**DRAFT DOCUMENT OF WORKING ISSUES
TO ADDRESS
WITH CONDITIONS OR PROFFERS**

Stonewall Secure Business Park, SPEX-2008-0068 (Office, administrative, business and professional, which do not meet the criteria contained in Section 4-503(G) and Floor area ratio up to 0.60 for office and data center uses), SPEX-2008-0069 (Water storage tank), SPEX-2008-0070 (Water treatment plant), SPEX-2010-0018 (Firearm range, archery range, indoor), and SPEX- 2010-0034 (Utility Substation, Transmission)

SUBJECT: ZMAP 2008-0017, Stonewall Secure Business Park (SSBP), 3rd Referral
SPEX 2008-0068, SSBP - Office & 0.6 FAR, 3rd Referral
SPEX 2008-0069, SSBP - Water Storage Tank, 3rd Referral
SPEX 2008-0070, SSBP - Water Treatment Plant, 3rd Referral
SPEX 2010-0018, SSBP - Indoor Firearm Range, 3rd Referral
SPEX 2010-0034, SSBP - Utility Substation, Transmission, 1st Referral
CMPT 2010-0014, SSBP - Utility Substation, Transmission, 1st Referral

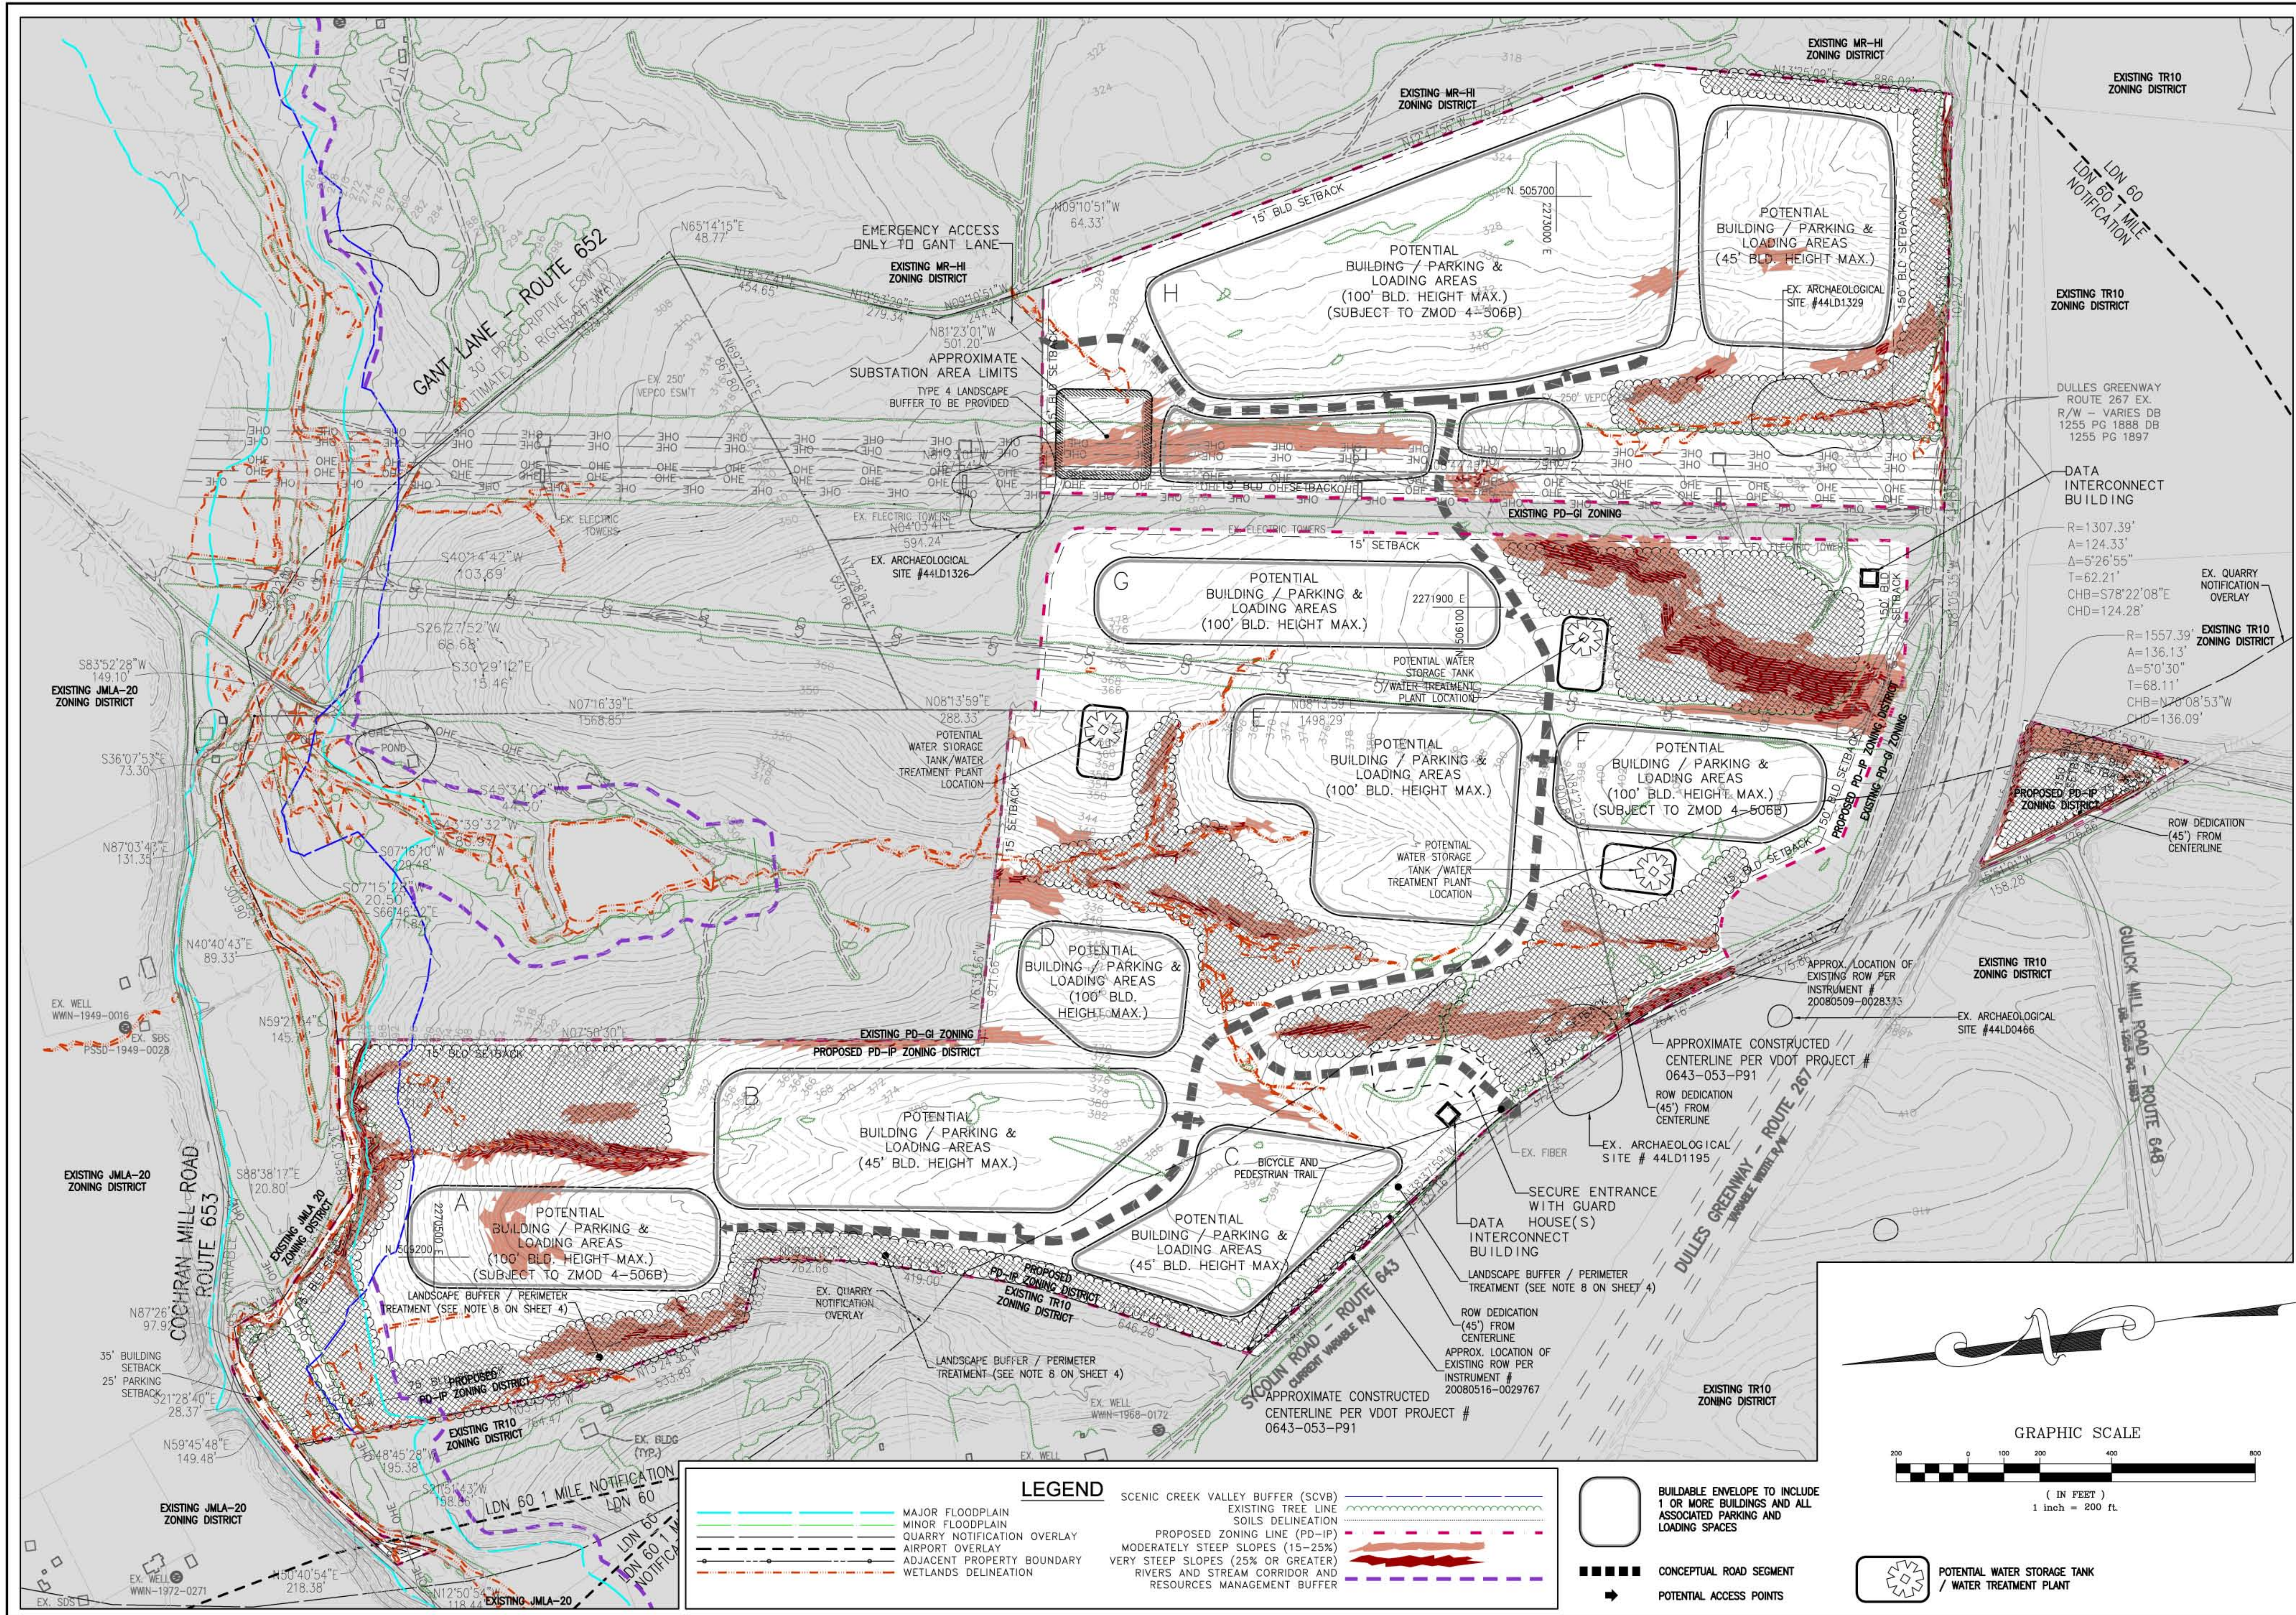
23. In regard to proffer III.8., the "Management Buffer" needs to be labeled on sheet 4, or otherwise shown in the legend. Because they are both purple, it is difficult to tell the Management Buffer from the SCVB. Staff suggests these be clearly labeled and depicted with different colors. Finally, on sheet 5, the Management Buffer is difficult to see against the topography lines. Revise accordingly.

16. Reference should be made to the indoor firearm range on the special exception plat (sheet 4). (Prior comment D.7.)
17. On sheets 4 and 5, the potential water storage tank/water treatment plant is not within an area designated for potential building. Please create building/parking envelopes for these potential locations.

18. In regard to note 8 on sheet 4, the applicant will be subject to the buffer yard requirements of Section 5-1400. Amend this note to state compliance with Section 5-1400. Additionally, a type 3 buffer is required where the property fronts an existing or planned four-lane divided roadway.

A note has been added to Sheet 4 to state that the indoor firing range/archery range uses shall not be located in Land Bays A, B or C which are adjacent to residential uses.

7. SEE SHEET 2 FOR OPEN SPACE AREAS AND CALCULATIONS
 8. THE BUFFER YARD REQUIREMENTS SHALL COMPLY WITH SECTION 5-1400. A TYPE 3 BUFFER IS REQUIRED WHERE THE PROPERTY FRONTS AN EXISTING OR PLANNED 4 LANE DIVIDED ROADWAY.

11. INDOOR FIREARM/ARCHERY RANGE WILL NOT BE LOCATED WITHIN LAND BAYS A, B & C.

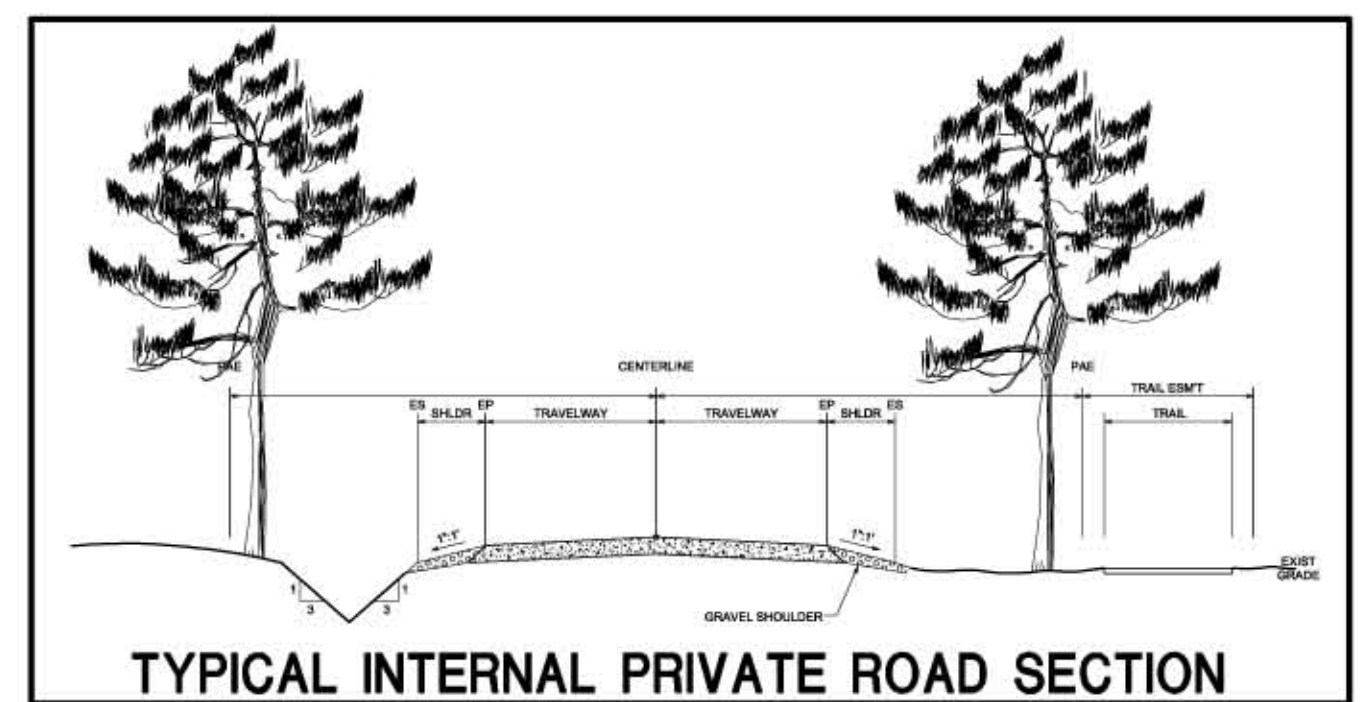
19. A number of the labels on sheet 5 are difficult to read because of the multiple overlays. Ensure that all text can be easily read.

17. On sheets 4 and 5, the potential water storage tank/water treatment plant is not within an area designated for potential building. Please create building/parking envelopes for these potential locations.

Sheets 4 and 5 have been revised to show the potential water storage tank/water treatment plant locations within building/parking envelopes, as requested.
